Accessibility Review Report – SSDA

Project Title: SSD-70283710
1 Crescent Street, Holroyd

Report Version: 22626_ADR_SSDA_v1.0

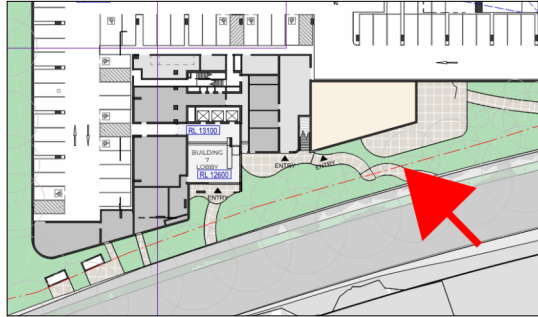
- Buildings 4 + 5 –
 - Red arrows identifies stairway access to the raised podium area between Buildings 4 + 5; and identifies a series of stairs along the internal site pathway into the development.

The identified non-accessible entrances will need to be addressed via a Performance Solution report. Reliance will be played on an internal management system to enable wayfinding through the site.

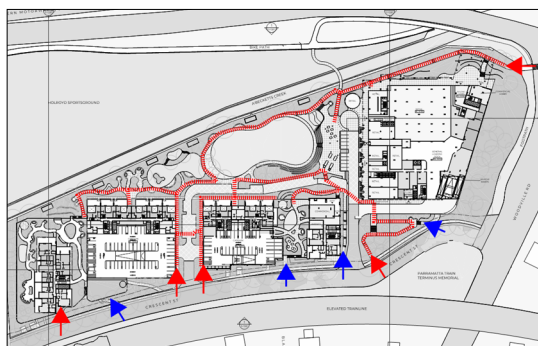
- A'becketts Creek bridge confirm whether this feature is part of the clients allotment or whether this is part of council's land.
If part of the clients allotment, these feature will be required to achieve compliance with AS1428.1-2009.

Figure 2 –

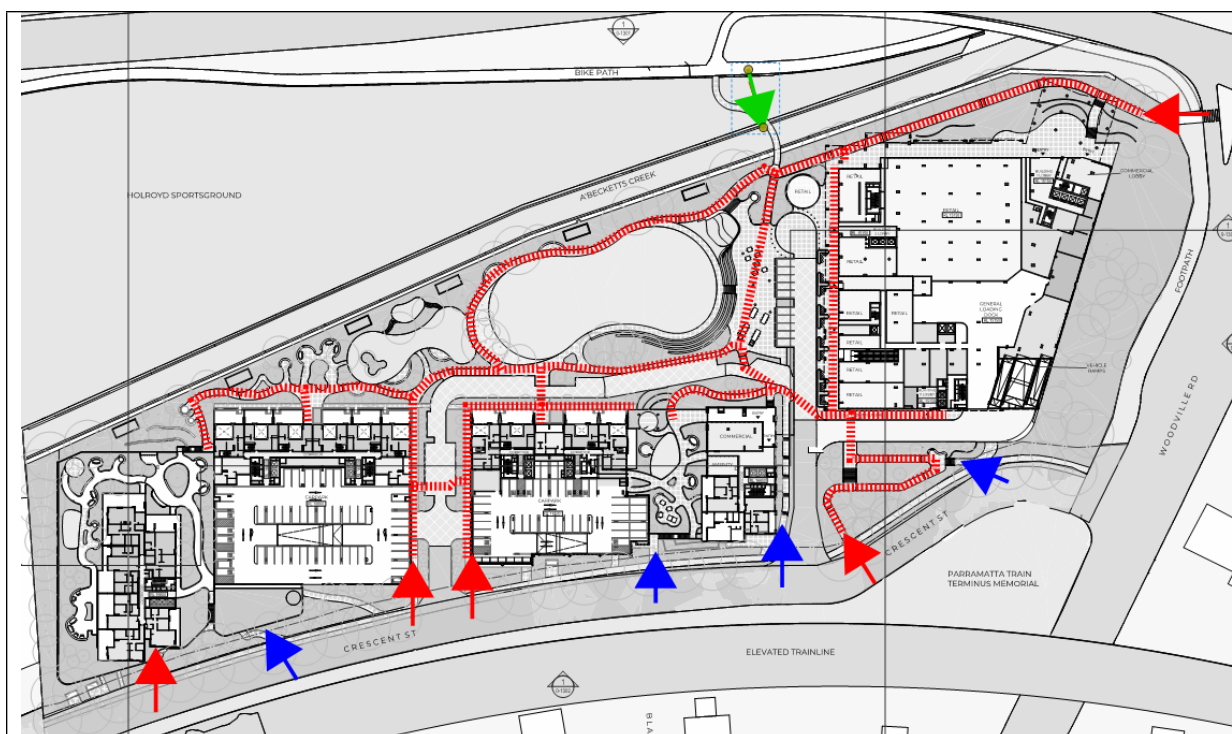
Numerous entrances off the Crescent Street frontage are not provided with an accessway, these include:

- Buildings 4 + 5 – Stairway Access only

- Buildings 6 + 7 – An accessway between the Crescent Street and Ground Floor external podium between Buildings 6 & 7.

Red Arrows indicate locations of accessible entrances off the allotment boundary

Blue Arrows indicate location of non-accessible entrances from the allotment boundary

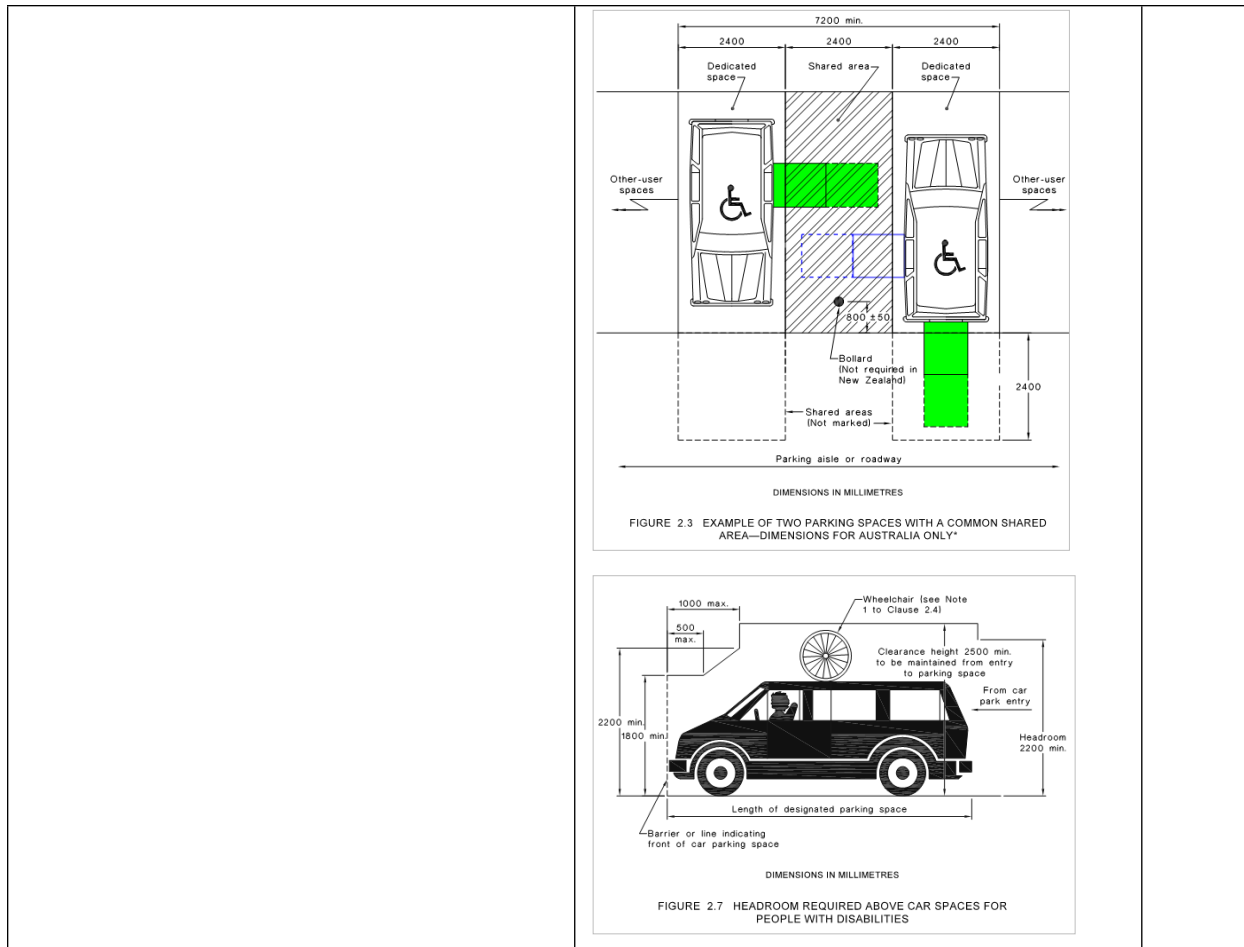
parking spaces which are obstructed by a column. The column is currently located within the loading and unloading zone of a wheelchair occupant and the parking spaces will need to be re-adjusted. (i.e. located >1750mm into the space OR more than 1x column within the shared zone). <u>Performance Solution:</u> A Performance Solution will be prepared to address use of columns within the shared zones adjacent to the accessible parking space. Columns shall not impact loading and unloading zones. <u>Visitor Carparking –</u> The BCA does not specify any requirements for visitor car parking / accessible car spaces for visitors. This item is driven by the Council DCP requirements. Within the development 5x visitor parking space are provided per phase. A total of 3x accessible car spaces have been allocated for visitors. <u>Detail Design:</u> Accessible visitor parking spaces shall be relocated to ensure nil obstruction is provided from a column within the shared zones. <u>Class 6 (Commercial/ Retail) Parking –</u> Within the development a total of - Phase 1: 118x car spaces - Phase 2: 3x car spaces

have been nominated for the retail/ commercial (class 6) portions of the building. - Phase 1 = 3x Accessible parking spaces - Phase 2 = 1x Accessible parking spaces accessible car spaces are identified allocated to serve the Class 6 portion of the development to meet the minimum BCA requirement under Cl. D4D6. <u>Design Details –</u> • Minimum 2.2m head height clearance from the entrance to the accessible carparking spaces. • Minimum 2.5m head height clearance at the accessible carparking spaces and shared zones. Ensure any proposed mechanical ducting / services within the identified zones does not encroach on the specified height above an accessible car space. • Minimum dimensions of accessible car spaces and shared zones 5400mm x 2400mm. • Line marking, bollards and signage to be specified and comply with AS/NZS2890.6-2009. • Structural columns or other encroachment are not permitted in the accessible car space or shared zones. • Accessible car space must be on-grade and not have a fall or crossfall steeper than 1:40. • An accessway from any accessible car space must be provided to the building/passenger lift/lobby etc. Refer to key figures/extracts below from AS/NZS2890.6-2009:
